Mixer Lower Ladder Platform Weld Inspection

Date: 06-09-15
Bulletin Name: MXR-TSB-024
Model: Mixer
Affected Units: Bridgemaster V Mixer and Standard Mixer

Figure 1: Locate the lower ladder platform.

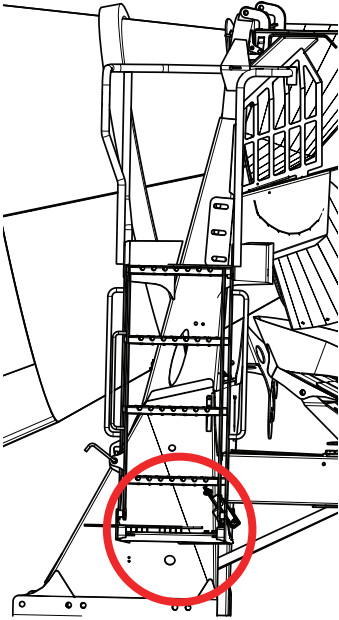
McNeilus Truck and Manufacturing requires the inspection of mixer lower ladder platform welds on Bridgemaster V Mixers and Standard Mixers. A vendor manufactured lower ladder platform may not have been manufactured with all the necessary welds. The amount of weld currently on the platform is enough to be structurally sound. However, if the welds are not present, McNeilus requires the ladder platform be replaced because of the possibility of corrosion on an unwelded platform. There is no affect to driving capabilities of the Mixer vehicle.

1. Place unit on a flat surface, block truck tires, and observe all conditions of the Safety Notice concerning Lockout/Tagout posted in the Notice section of this bulletin.
2. Locate the areas of the possibly missing welds (see Figure 1 for the location of the ladder platform. See Figure 2 for location of missing welds on the lower ladder platform).
 - If the welds are missing, order a new lower ladder platform by calling McNeilus Parts at 888-686-7278. Once you receive a new platform, follow the Procedure for Lower Ladder Platform Installation in this bulletin for installation instructions.
 - If the welds are in place, this bulletin is complete. Remove the conditions of Lockout/Tagout and return the vehicle to service.

Figure 3: Remove and discard the (4) bolts and (4) nuts from the ladder side of the platform.

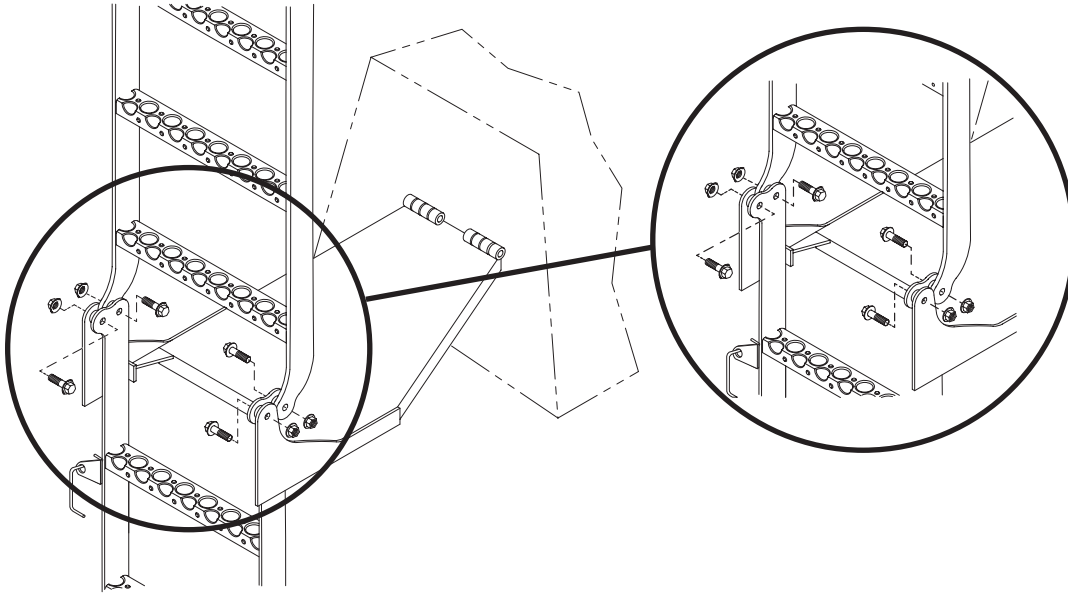
- The platform is secured to the upper ladder by (2) bolts and (2) nuts, to the lower ladder by (2) bolts and (2) nuts, and to the rear platform by (2) bolts and (2) nuts.
1. Place unit on a flat surface, block truck tires, and observe all conditions of the Safety Notice concerning Lockout/Tagout posted in the Notice section of this bulletin.
 2. Lower the fold-down ladder. While the second person is holding up the platform and holding onto the fold-down ladder, the first person should remove and discard the front (4) bolts and (4) nuts from the platform on the **ladder side** (see Figure 3 which shows removal from one side only).

Figure 4: Remove and discard the (2) bolts and (2) nuts from the rear pedestal side of the platform. Only one side shown here.

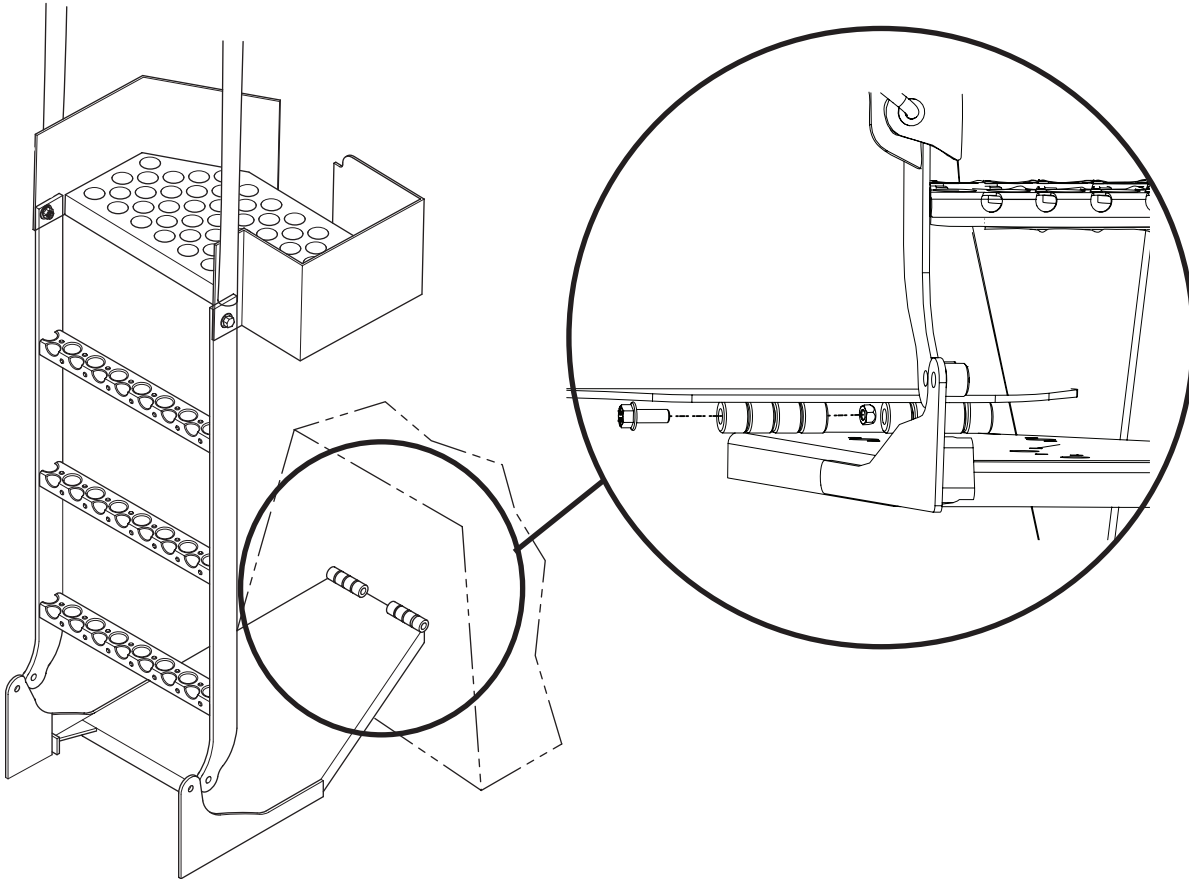
4. Remove and discard the bolts and nuts from the platform on the rear pedestal end (see Figure 4).

Figure 5: Install the (2) bolts and (2) nuts to secure the new platform to the rear pedestal side. Only one side shown.

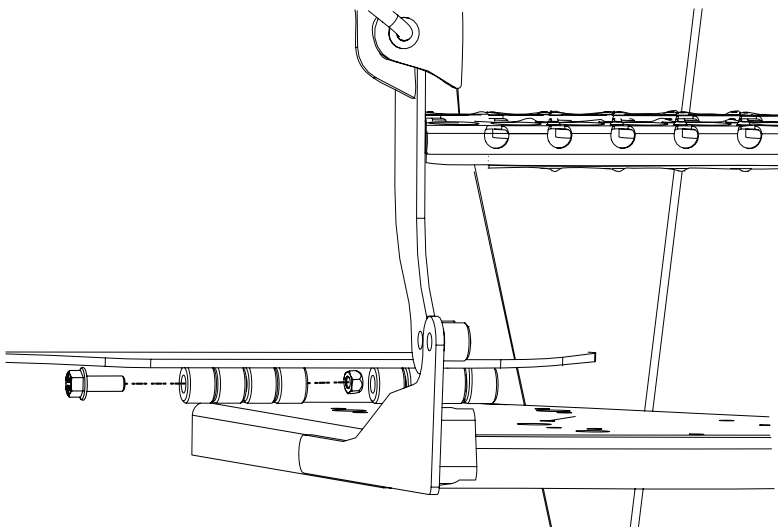
5. Remove and discard the existing lower ladder platform. (See the warranty reimbursement section of this bulletin and step 12 for specific instructions before discarding the existing platform.)
6. Install the new lower ladder platform (P/N 1109058) by first having the second person hold it in place.
7. Install the new (2) bolts and (2) nuts to secure the platform to the rear pedestal (see Figure 5 - only one side shown for illustrative purposes).

Figure 6: Install the new (4) bolts and (4) nuts to secure the platform to the ladder side.

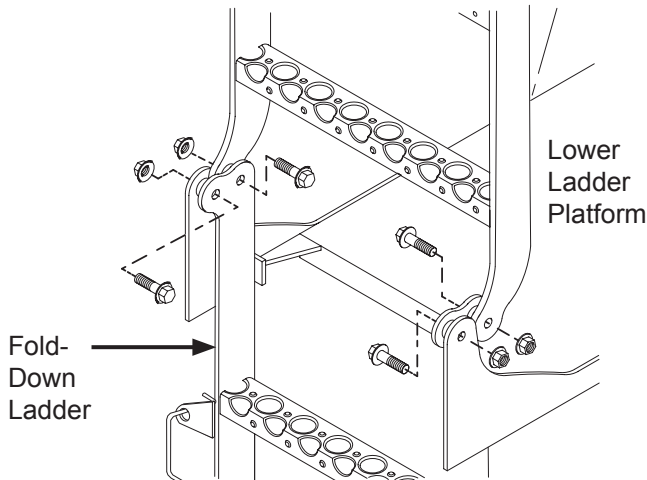
8. Line up the fold-down ladder to the lower ladder platform and upper ladder as shown in Figure 6. The second person should hold both the fold-down ladder and the new platform for steps 9 and 10.
9. Install the new (4) bolts and (4) nuts to secure the platform to the ladder (see Figure 6).

10. Use a torque wrench to torque the bolts to 80 ft-lbs.
11. Installation of the lower ladder platform is complete. Remove the conditions of Lockout/Tagout and return vehicle to service.
12. Follow the normal warranty claim process, which includes providing McNeilus Warranty photo evidence that the original lower ladder platform **did not** have the proper welds.
